3rd Further Information

Proposed Temporary Shop and Services, Eating Place and Public Vehicle Park
(Excluding Container Vehicle) for a Period of 5 Years in "Residential (Group C)" Zone,
Lots 347 S.B (Part), 347 S.D (Part) and 348 (Part) in D.D. 109, Kam Tin, Yuen Long, New Territories

(S.16 Planning Application No. A/YL-KTS/1088)

Response-to-Comment (RtC)

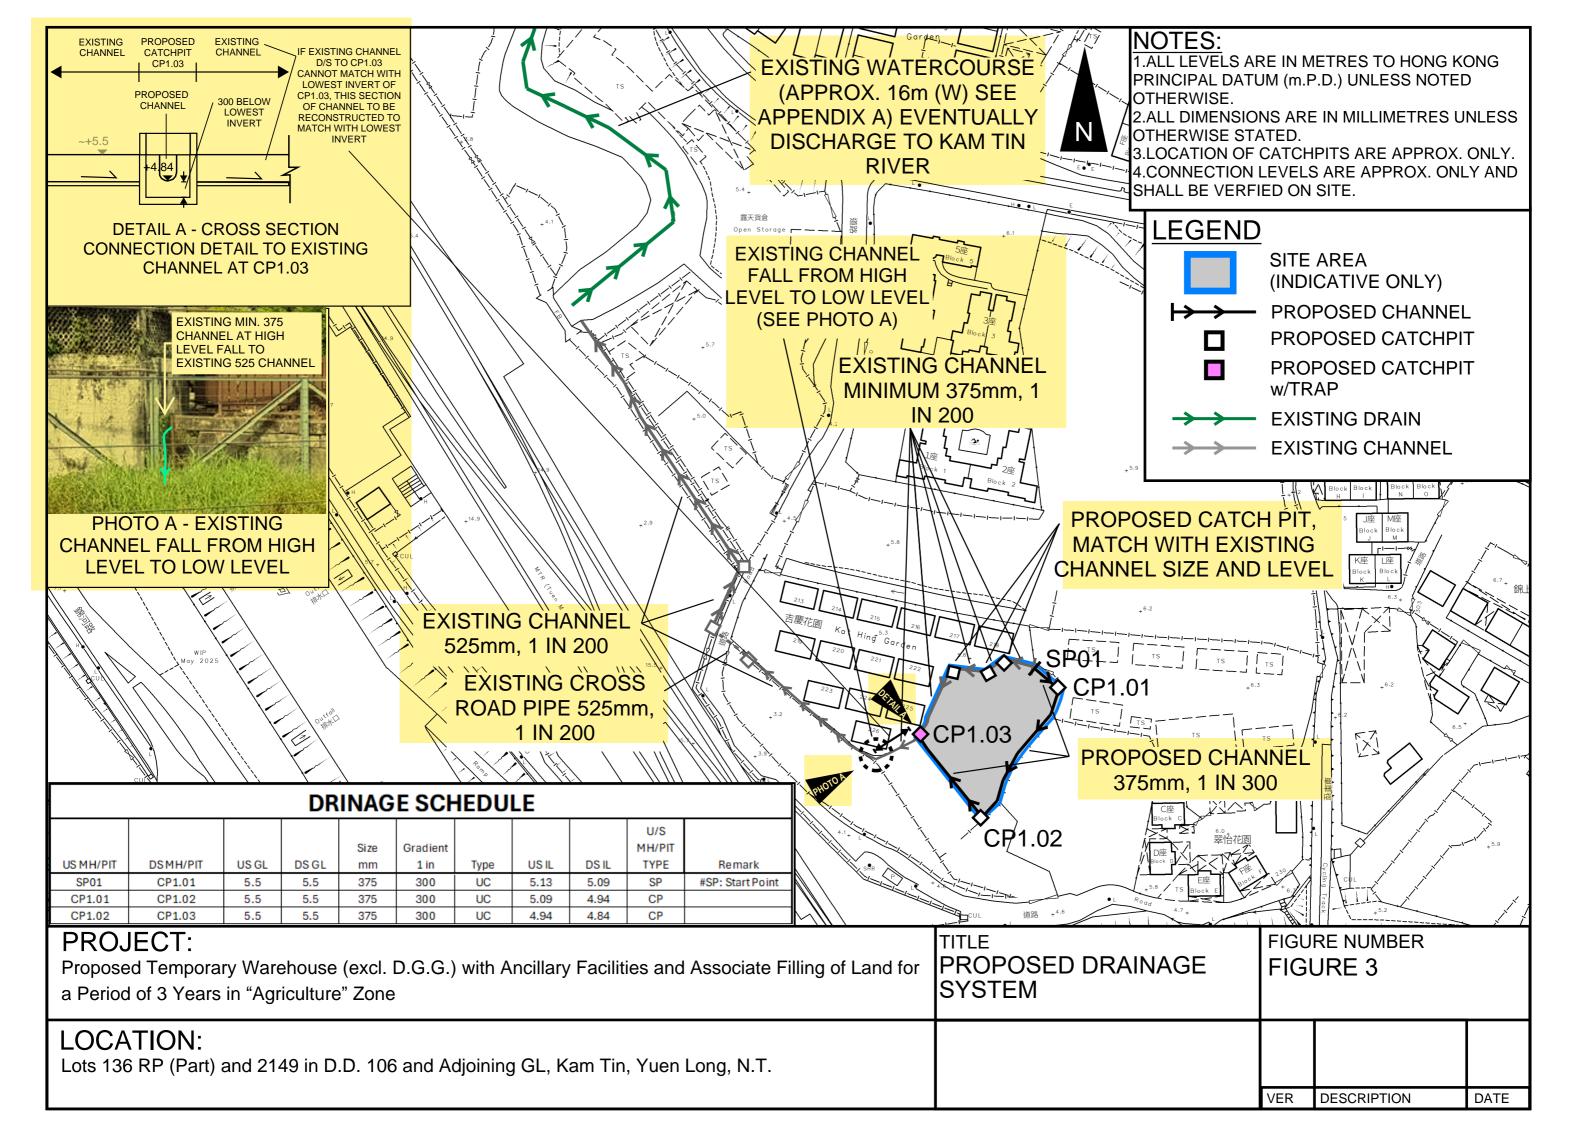
| | drains/channels and/or modifying/upgrading existing ones in other private lots or on Government land outside the application site. | |
|-----|--|--|
| (g) | Connection details at discharge point (including cross section) with C.L., I.L and catchpit/channel B.L. should be shown in the drawing. | Noted. Please refer to <i>Detail A</i> and <i>Photo A</i> in updated <i>Figure 3</i> for your perusal (Annex I). |

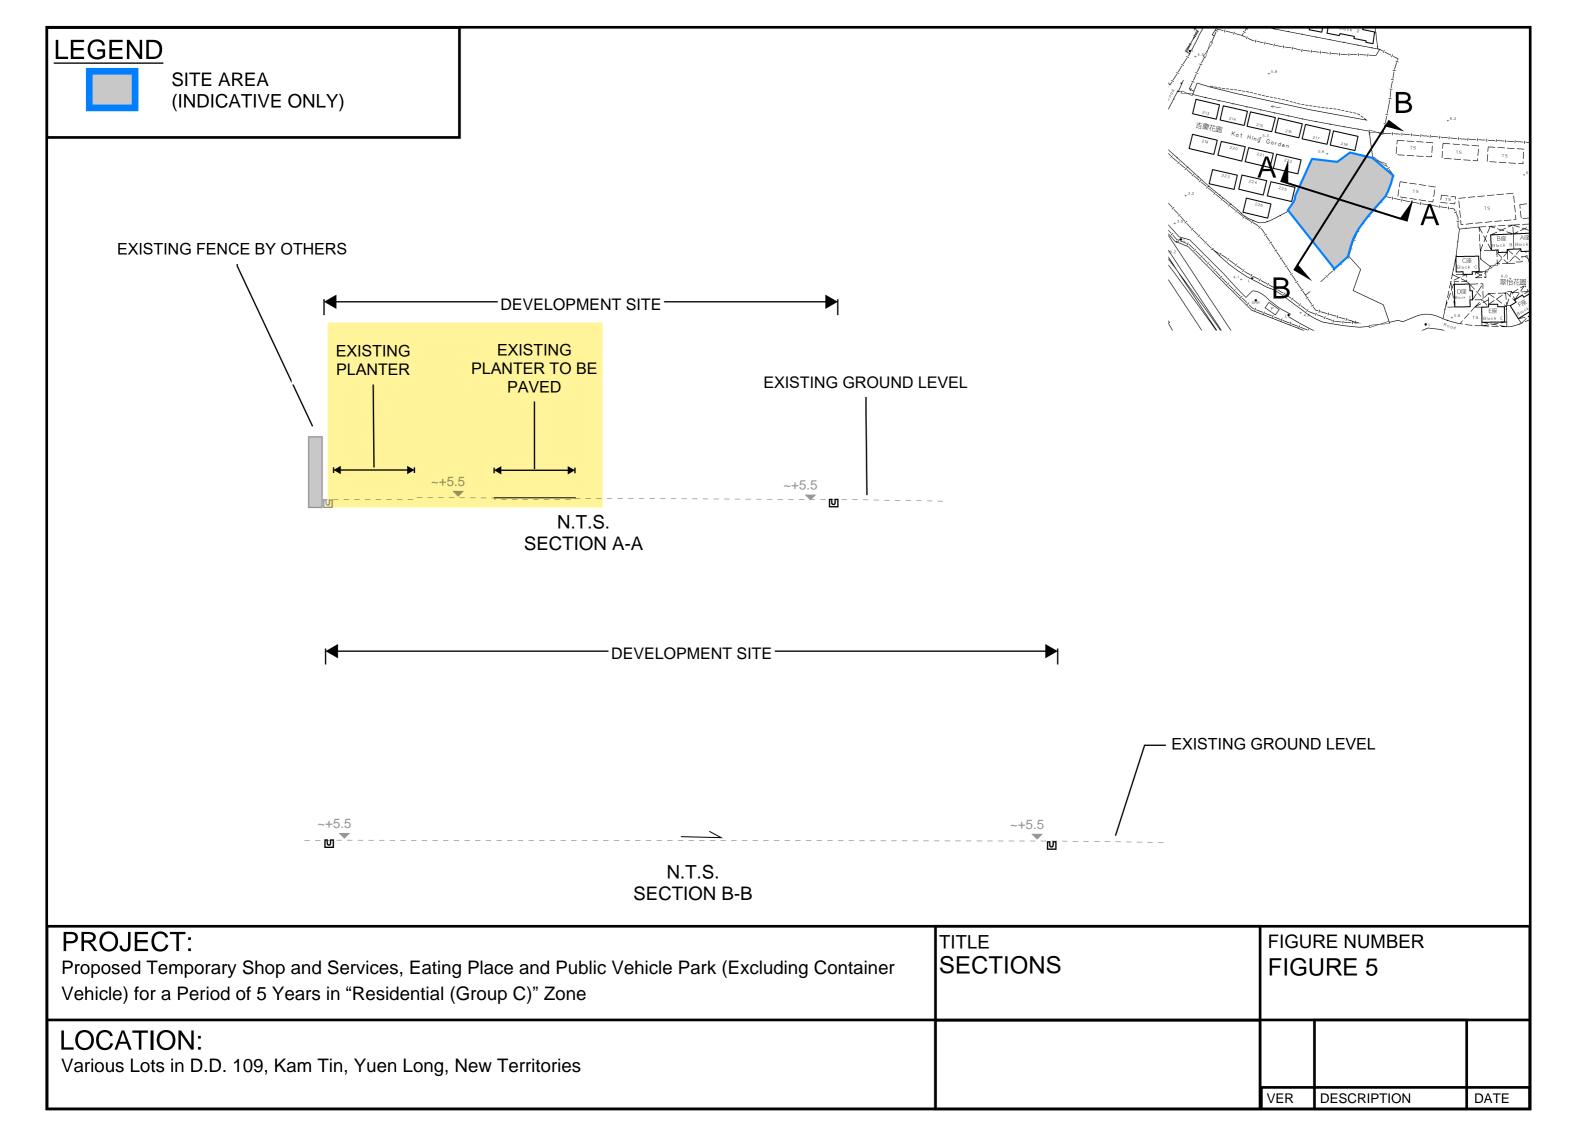
| | drains/channels and/or modifying/upgrading existing ones in other private lots or on Government land outside the application site. | |
|-----|--|--|
| (h) | Please include the existing planter details in section A-A. | Noted. Please refer to updated Figure 5 (Annex I). Please kindly note that the existing planter level is about the same level of existing paved area. Overland flow would not be obstructed by existing planter. |

Appendix C - Reference Drawings

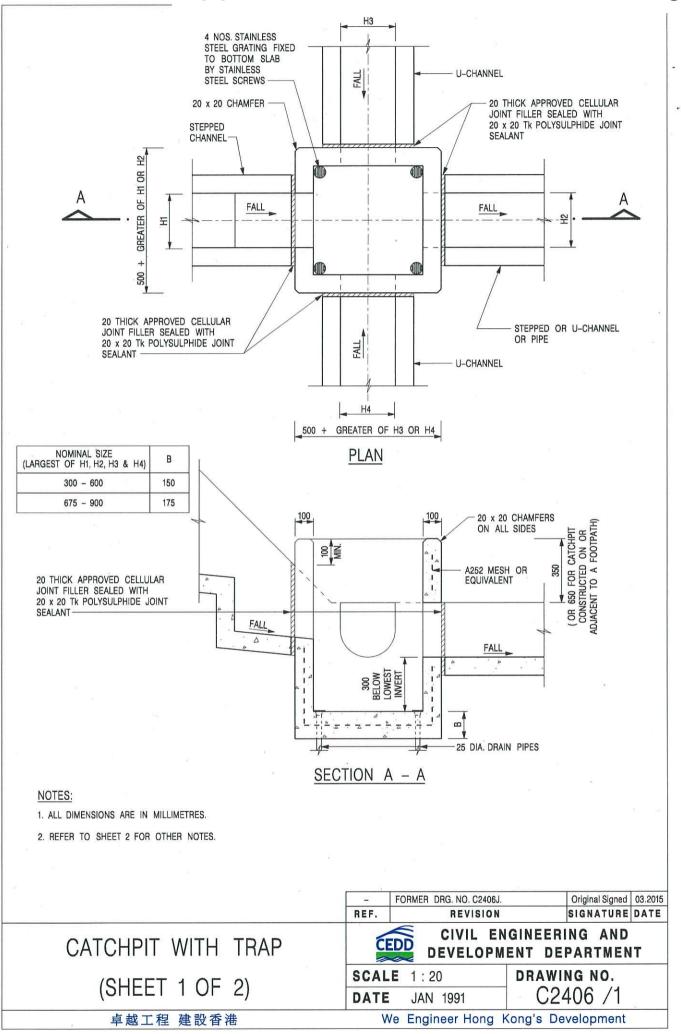
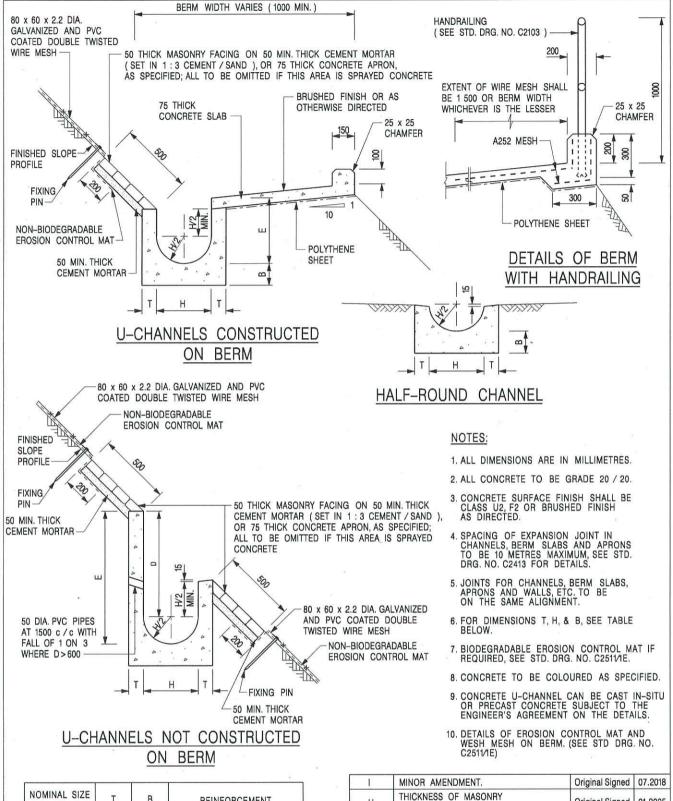
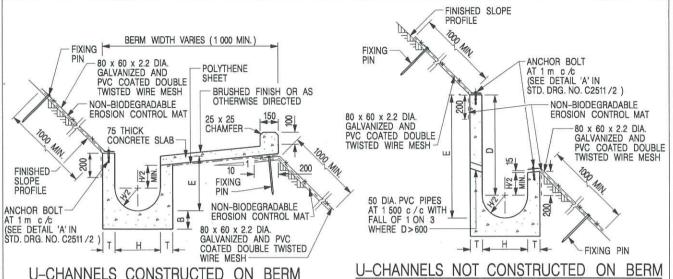
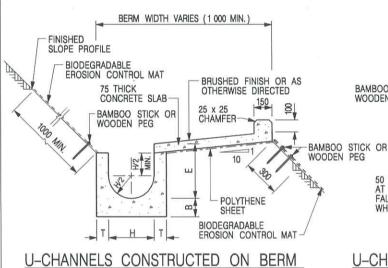
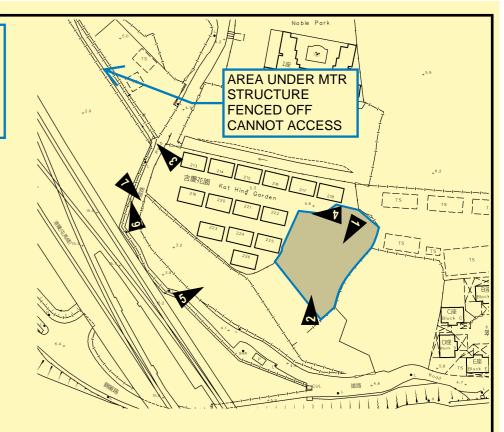
| | Departmental Comments | Applicant's Responses | | | | | |
|------|---|---|--|--|--|--|--|
| (d) | Standard details should be provided to indicate the sectional details of the proposed u-channel and the catchpit/sand trap. | Noted. Please find the standard details of channel in <i>Appendix C</i> for your perusal (Annex I). | | | | | |
